CITY OF CARMEL-BY-THE-SEA PLANNING COMMISSION Staff Report

TO:	Chair LePage and Planning Commissioners
SUBMITTED BY:	Marnie R. Waffle, AICP, Principal Planner
APPROVED BY:	Brandon Swanson, Director of Community Planning & Building
SUBJECT:	DR 16-384 (Fountain): Consideration of a Design Review, Use Permits, and associated Coastal Development Permit for application DR 16-384 (Fountain) for the construction of a 1,600-square-foot, mixed-use building with a 1,499-square-foot basement and a 595-square-foot car pit on a vacant lot located on 8th Avenue 2 northwest of Junipero Street in the Residential & Limited Commercial (RC) District. APN 010-087-020

Application: DR 16-384 (Fountain)

SOUTH ELEVATION
 SCALE: 1/4" = 1'-0"
 0 2 4 6 8 10 12 14 16 18 20

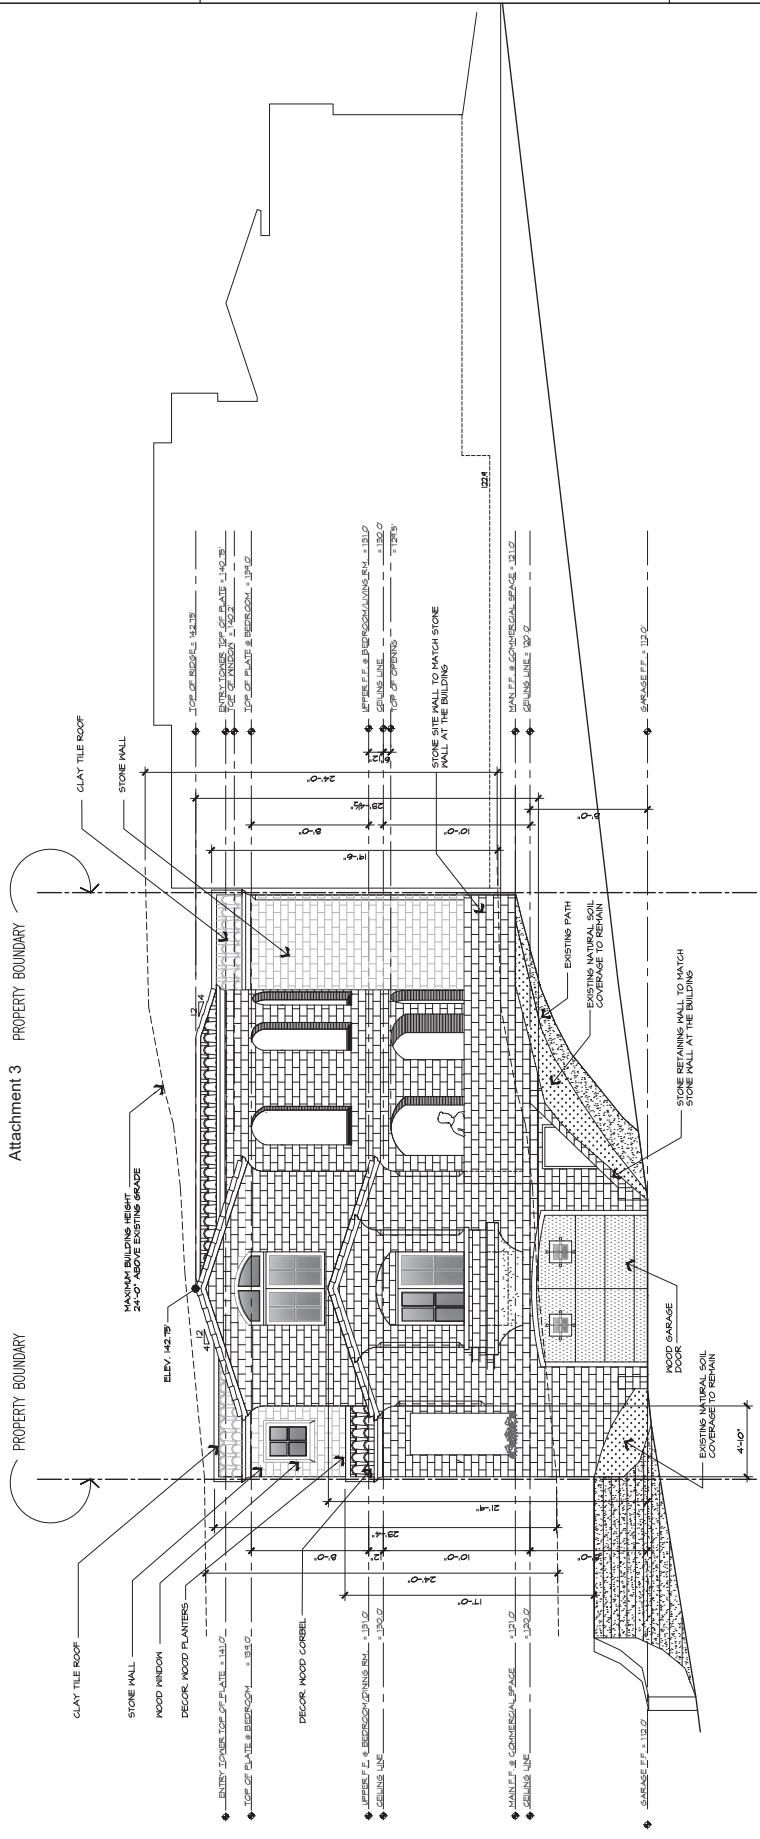
Staff Response: The applicant proposes a mixed-use building that is no more than 24 feet tall and two stories above grade. The front (south) elevation includes an at-grade garage with commercial office space above. On the uphill (north) side of the lot, the residential unit has been set back 4'-6" in order to maintain two stories above grade. As described above, those portions of a partially subgrade space used for parking are counted as a story when the finished floor above the space is five feet or more above the final grade adjacent to the exterior wall. Based on this definition, once the finished floor above the garage is less than 5 feet above the adjacent grade, it is no longer considered a story. The residential unit has been set back in order to avoid creating a three-story structure under the strict definition of the code.

Previous designs that set the garage below grade to minimize its appearance required driveway retaining walls that encroached into the right-of-way, which was ultimately not approved by the City Council. Setting the driveway at grade eliminates the need for driveway retaining walls in the public right-of-way but also makes the garage more visually prominent. The single-car garage opening is proposed to be 10 feet wide, and the garage door is proposed to be wood. The scale and finish materials are consistent with a residential garage door.

With respect to building height and the surrounding design context, the two-story City-owned Scout House is located to the west of the project site, and a two-story single-family residence is located to the east. Single-family residences to the south of the project site are primarily two-story. To the north is a two-story hotel, The Hideaway. Staff finds that the height of the proposed mixed-use building is consistent with the surrounding design context despite the three-story appearance as viewed from the south.

WEST ELEVATION

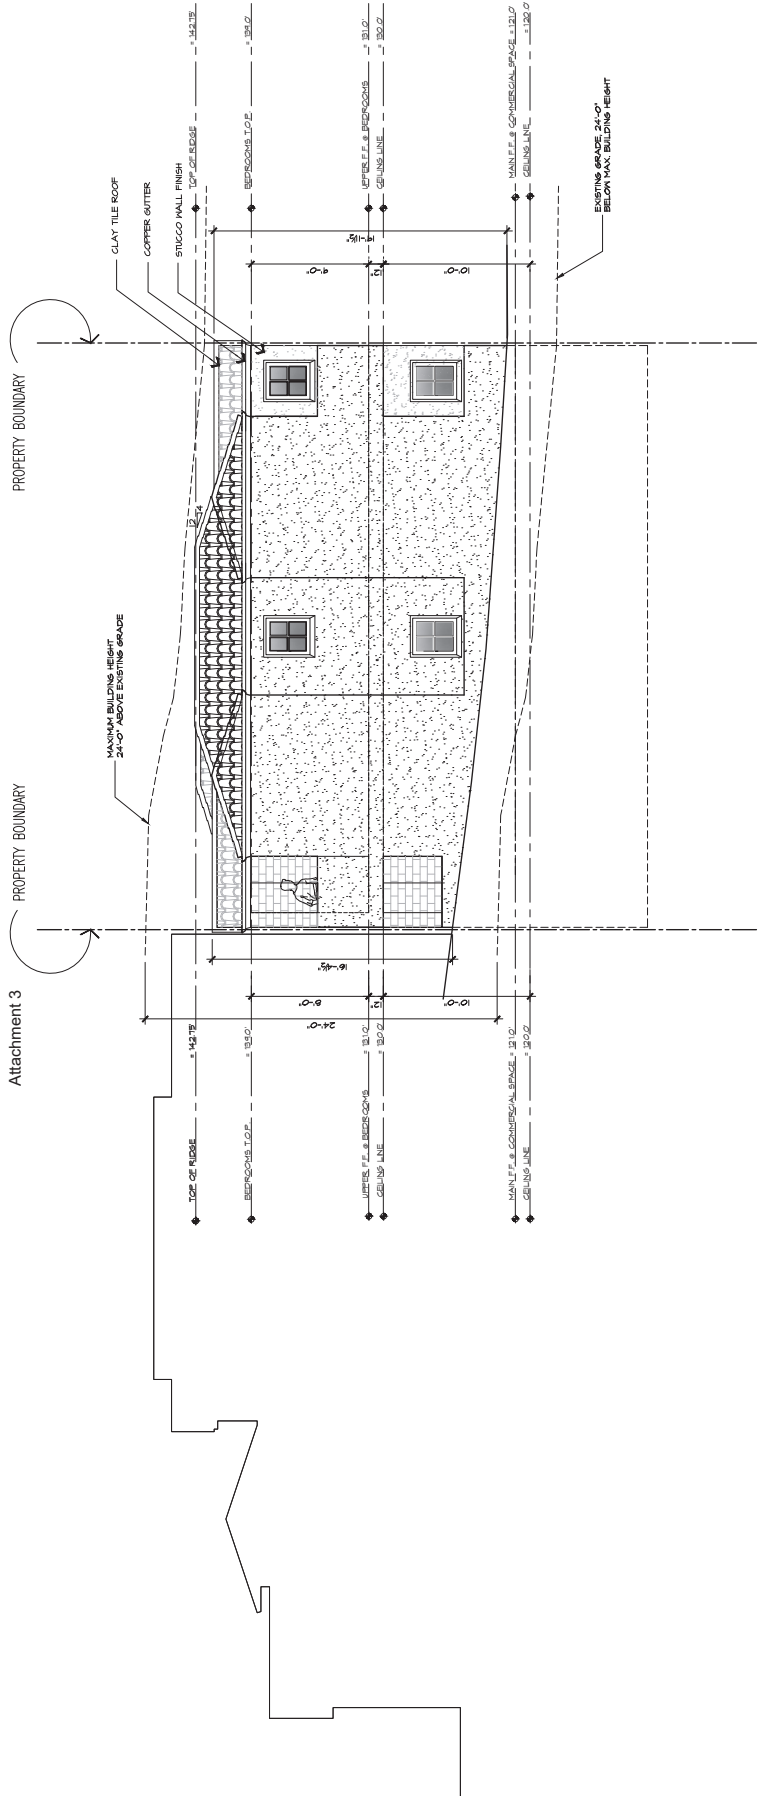
Staff Response: The wall cladding is primarily stone. The architectural elevations show some stucco portions on the west and north elevations however, the 3D color rendering shows just stone. The architectural elevations also include a call out for decorative wood planters and corbels however these are not shown on the 3D color rendering. The project includes wood windows and doors, a wood garage door, and a clay tile roof.
